Change 1 from NIC's new file 20220301:
The position for SD is longer
----- OK ,no problem from Hasion 3.1

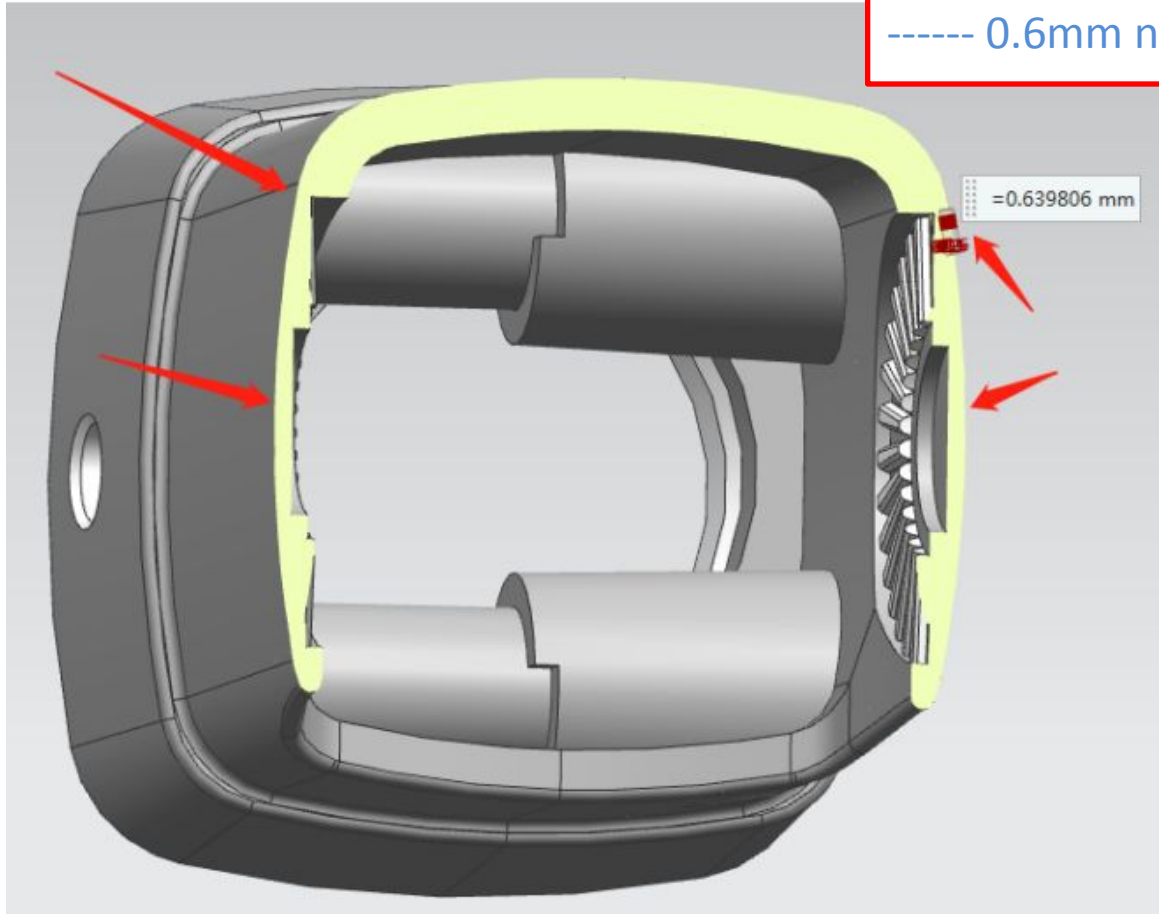
Change 2 from NIC's new file 20220301:
The position for gear
----- OK ,no problem from Hasion 3.1

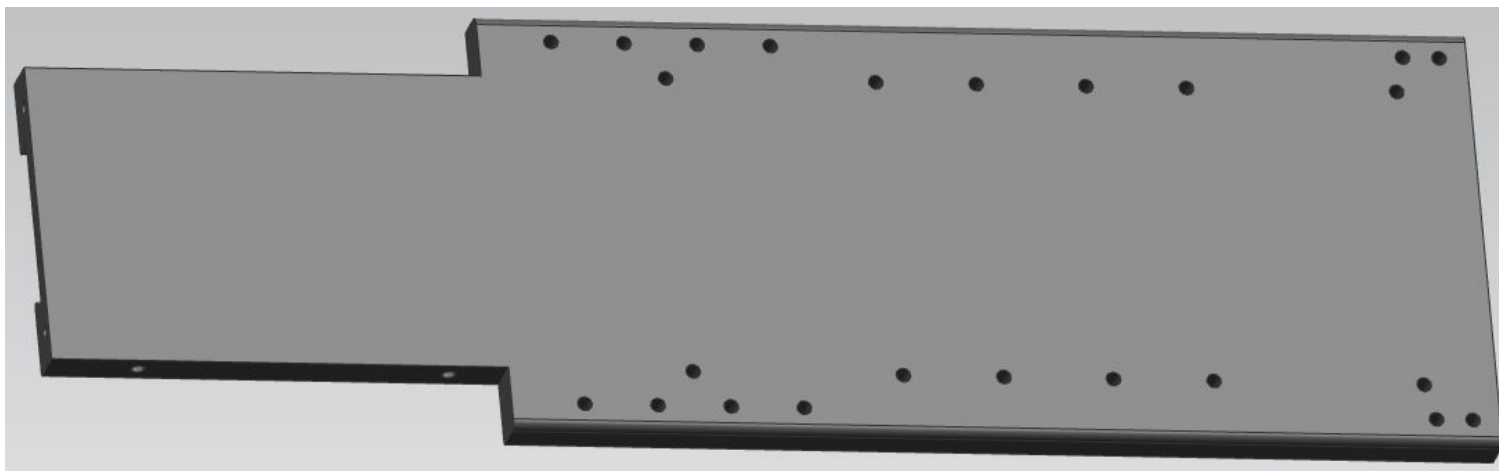
Change 3 from NIC's new file 20220301:

The thickness for here position

----- 0.6mm not OK , It at least 1.2mm--Hasion.3.1

because only 0.6mm thickness ,
too thin , easy to be broken

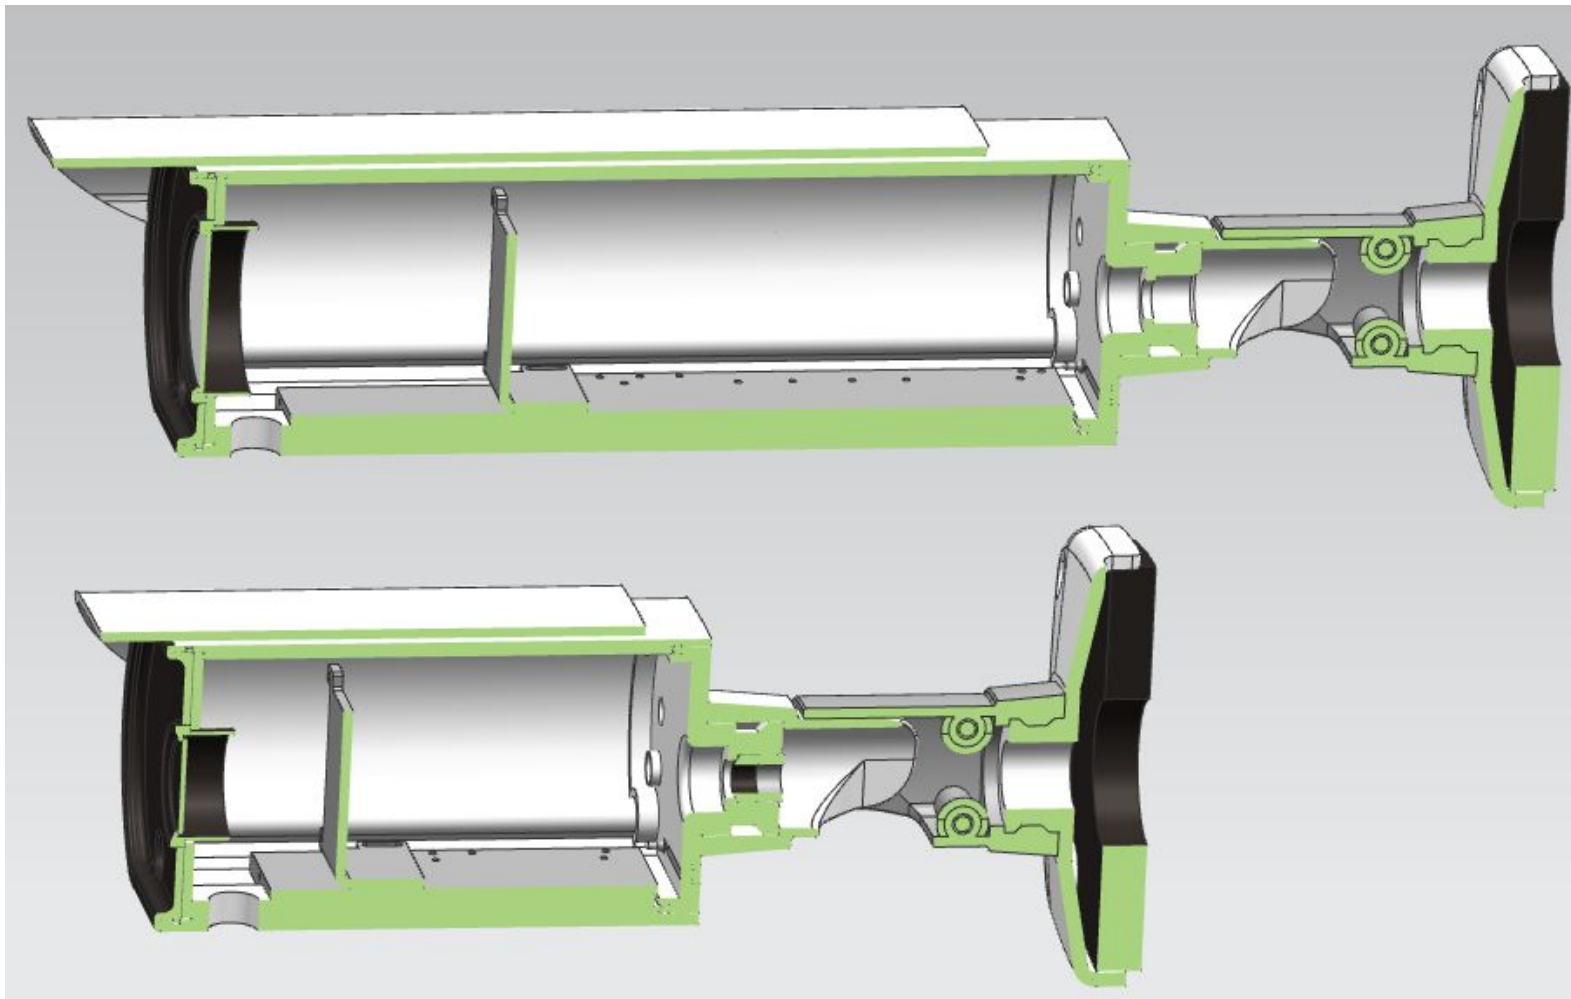
Change 4 from NIC's new file 20220301:
the hole is through hole type

Problem 5 from NIC's new file 20220301:
fixing way of the bracket board

-----the fixing way is not unreasonable, it doesn't improve the fixing --
Hasion 3.1
